G238HAN02.0_ Sponge added between the LGP and U-side ECR

G238HAN02.0 EC summary

As Is

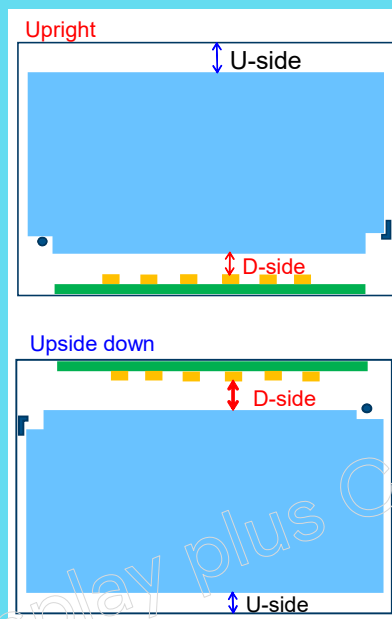
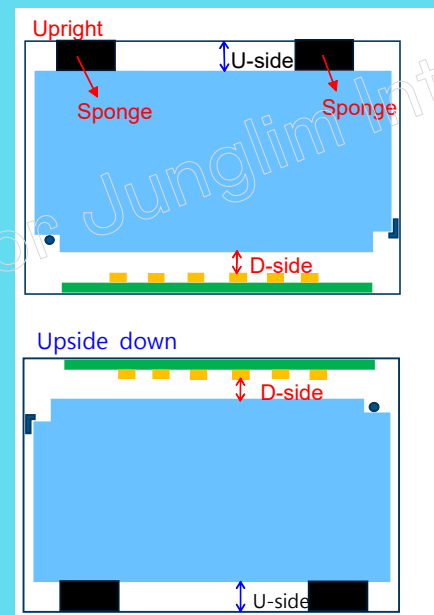
- EC Item: Sponge added between the LGP and U-side
- Background: The panel brightness variance occur when panel is placed upside down. The brightness variance of panel result from the little gap change between LGP and U-side when the panel is placed upside down.
- Structure enhancement : To reduce the panel brightness variation, we suggest to add the sponge between the LGP and U-side.
